**UNITED STATES  
NUCLEAR REGULATORY COMMISSION**  
WASHINGTON, D.C. 20555-0001

**SUBJECT: TURKEY POINT UNITS 3 AND 4 - ISSUANCE OF AMENDMENTS  
REGARDING EXTENDED POWER UPRATE (TAC NOS. ME4907 AND  
ME4908)**

SAFETY EVALUATION BY THE OFFICE OF NUCLEAR REACTOR REGULATION  
RELATED TO AMENDMENT NO.249 TO  
RENEWED FACILITY OPERATING LICENSE NO. DPR-31 AND  
AMENDMENT NO. 245 TO RENEWED FACILITY OPERATING LICENSE NO. DPR-41  
FLORIDA POWER AND LIGHT COMPANY  
TURKEY POINT PLANT, UNIT NOS. 3 AND 4  
DOCKET NOS. 50-250 AND 50-251

FIGURE 3.4-2 Turkey Point Units 3 and 4 Reactor Coolant System Heatup Limitations (Heatup Rates of 60 and 100°F/hr) Applicable for 48 EFY (Without Margins for Instrumentation Errors)

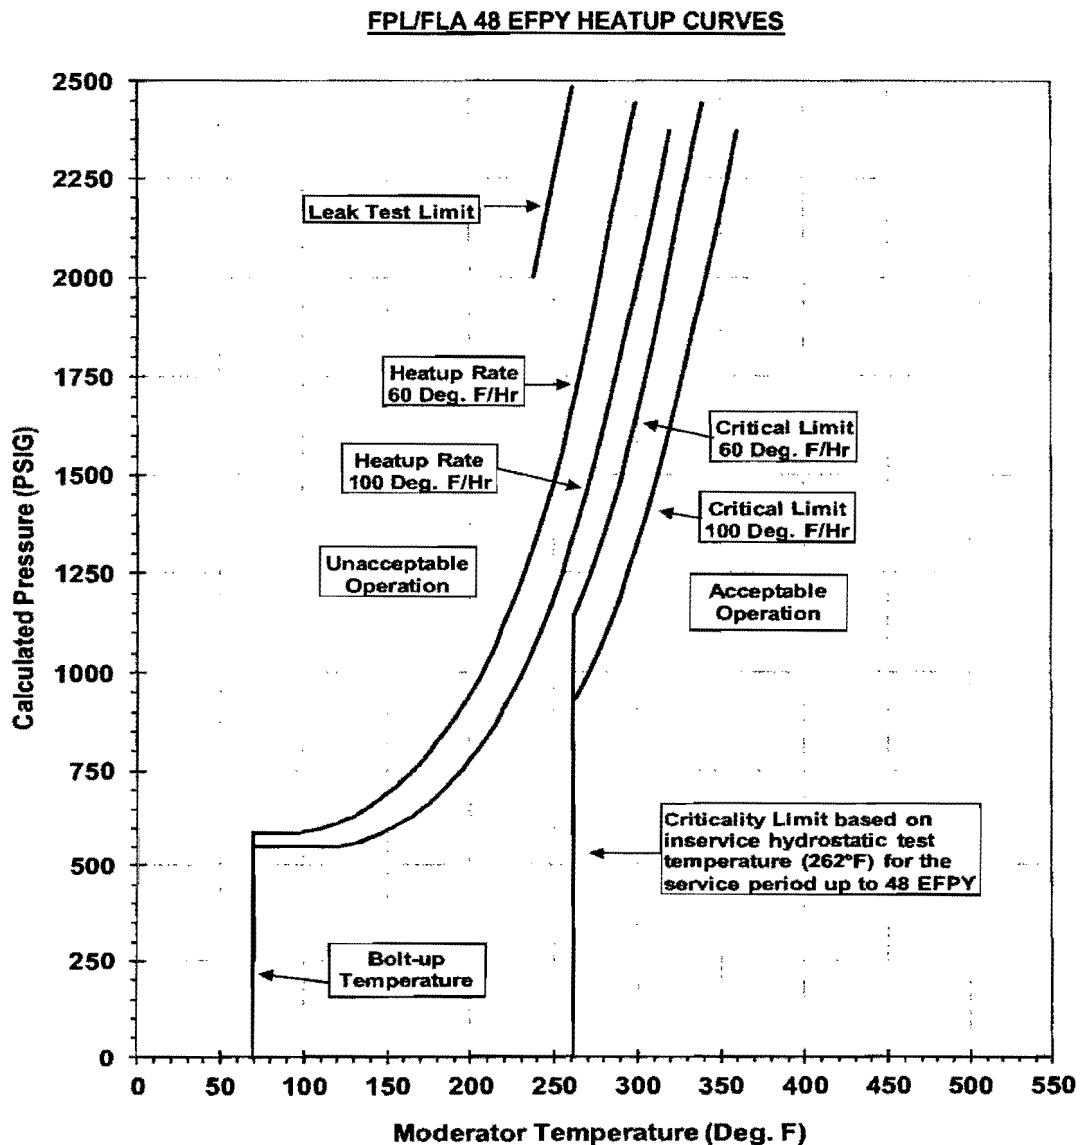
To support the EPU, the licensee prepared new P-T limits valid through 48 EFPY. Revised heatup curves were provided as technical specifications (TS) Figure 3.4.2, and the revised cooldown curves were provided as TS Figure 3.4.3. The same figures were provided as Figure 2.1.2-1 and 2.1.2-2 of the LR. The licensee provided a markup of TS Bases 3/4.4.9, which indicates that the licensee used the methodology of WCAP-14040-NP-A, Revision 2, "Methodology Used to Develop Cold Overpressure Mitigating System Setpoints and RCS [Reactor Coolant System] Heatup and Cooldown Curves."<sup>15</sup> The licensee also referenced "WCAP-15092, Revision 5, "Turkey Point Units 3 and 4 WOG [Westinghouse Owners Group] Reactor Vessel 60-Year Evaluation Minigroup Heatup and Cooldown Limit Curves for Normal Operation," as the basis for the current P-T limits, but did not provide the report with the EPU submittal. In a conference call on January 26, 2011, the licensee clarified that the WCAP-15092, Revision 5 report did not account for EPU, and that the methodology used to

develop the revised P-T limits was the same as described in WCAP-15092, Revision 3.<sup>16</sup> The minor changes from Revision 3 to Revision 5 did not affect the P-T limit curves.

**Figure 2.1-1 Reactor Core Safety Limit – Three Loops in Operation (Highest Loop Average Temperature (°F) vs Core Power (fraction of 2644 MWt) is as shown below**

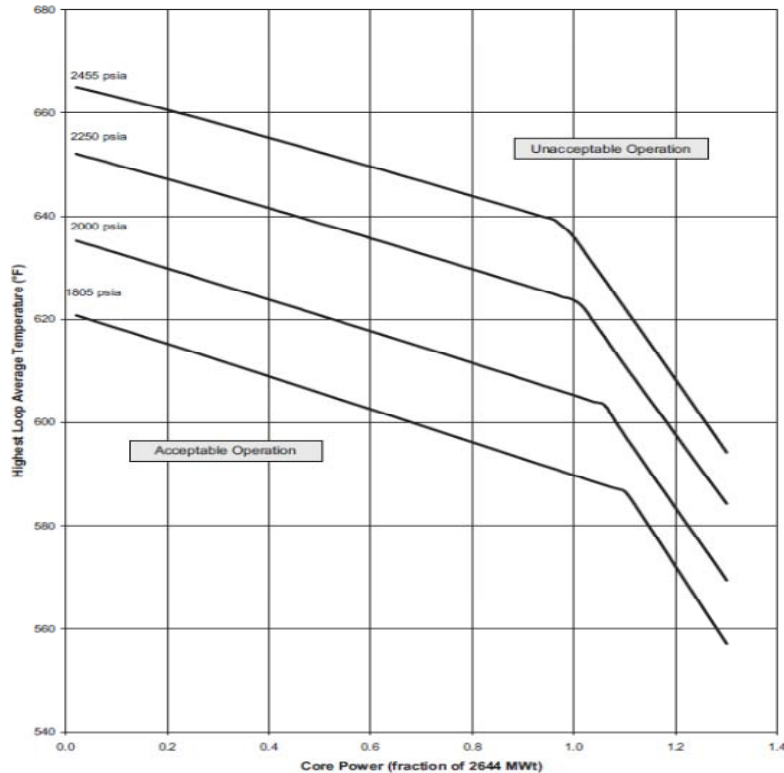
Proposed TS (NOTE: With the issuance of Amendment Nos. 247 and 243, Figure 2.1-1 has been relocated to the COLR. See explanation below.)

By Letter dated March 15, 2012,<sup>169</sup> FPL identified those COLR TS pages issued in Amendment Nos. 247 and 243 that supersede the EPU application TS pages. In addition, the licensee also stated that the EPU parameters included on these pages will be relocated to the COLR and that the values of the relocated parameters remain unchanged from the values reviewed by the NRC staff for the EPU LAR. Each COLR value submitted under the EPU LAR but which are relocated to the COLR as a result of the February 24, 2012, approval are described and evaluated in this safety evaluation. Figure 2.1-1 has been relocated to the COLR.

**Figure 3.1-1, “Required Shutdown Margin vs Reactor Coolant Boron Concentration,” is revised as shown in the figures below to provide a separate curve representing the minimum allowable shutdown margin in Mode 4 when no reactor coolant pumps are operating.**

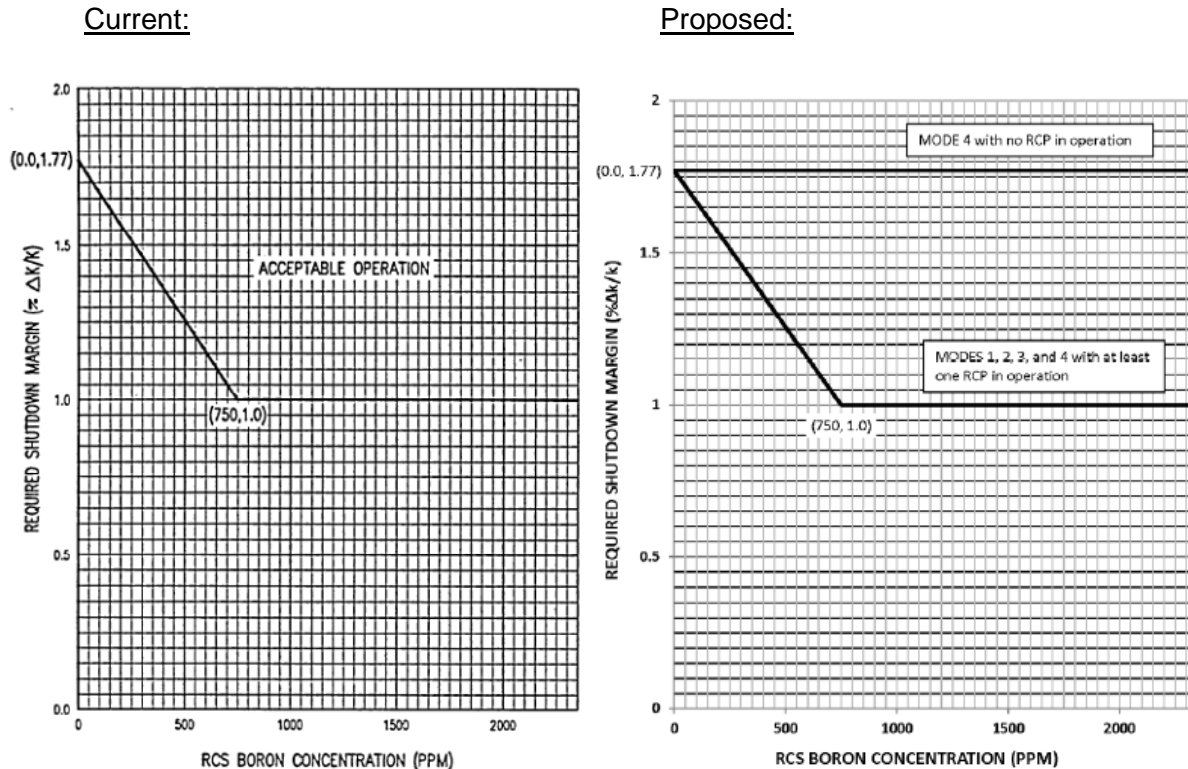
Proposed TS (NOTE: With the issuance of Amendment Nos. 247 and 243, Figure 3.1-1 has been relocated to the COLR. See explanation below.)

3.1.1.1 The SHUTDOWN MARGIN shall be greater than or equal to the applicable value shown in Figure 3.1-1.

**Figure 3.1-2 Boric Acid Tank Minimum Volume (1) – Modes 1, 2, 3, and 4 (Minimum BAT Volume vs BAT Inventory Concentration) is revised as shown below**

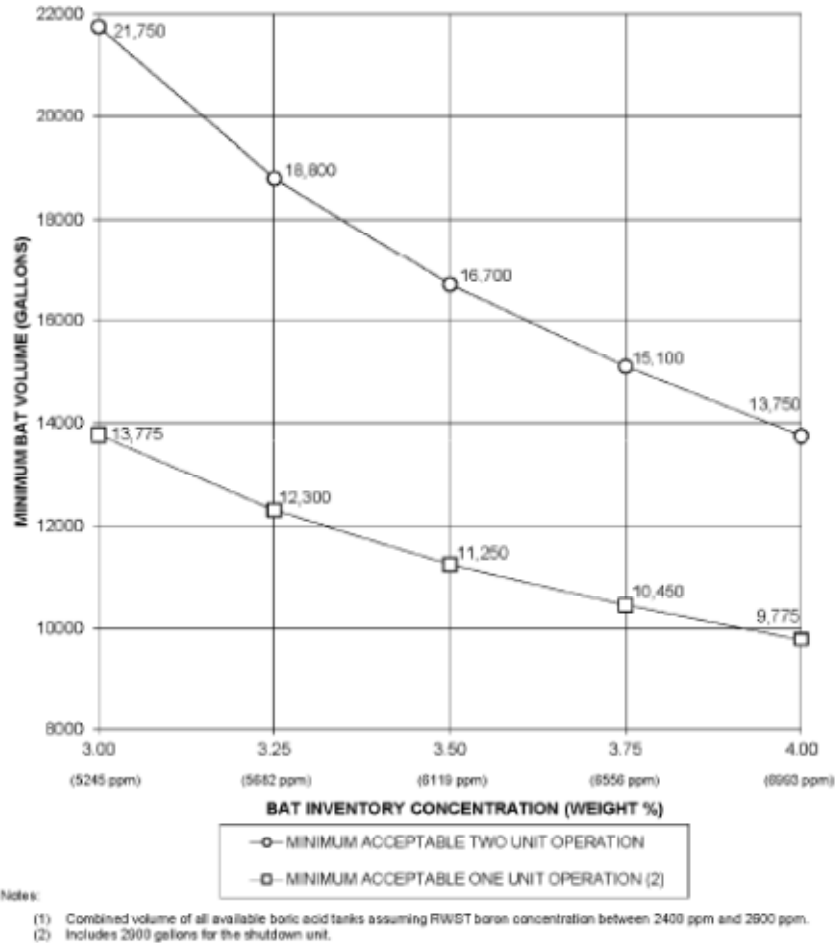
- c. With the boric acid tank inventory concentration greater than **4.0 wt%** verify that the boric acid solution temperature for boration sources and flow paths is greater than the solubility limit for the concentration.

In a supplement dated January 10, 2012 the licensee provided the above Figure 3.1-2 that included tank level instrument uncertainty and the following basis for the change.

The Boric Acid Tank Minimum Volume curve (submitted October 21, 2010) did not include tank level instrument uncertainty and is being revised to assure indicated level remained conservative. The total volumetric uncertainty including level measurement and minimum vortex volume has been determined to be limited to 600 gallons so that the minimum volume curves in Figure 3.1-2 have been revised to add 600 gallons for one unit operation and 1200 gallons for two unit operation.
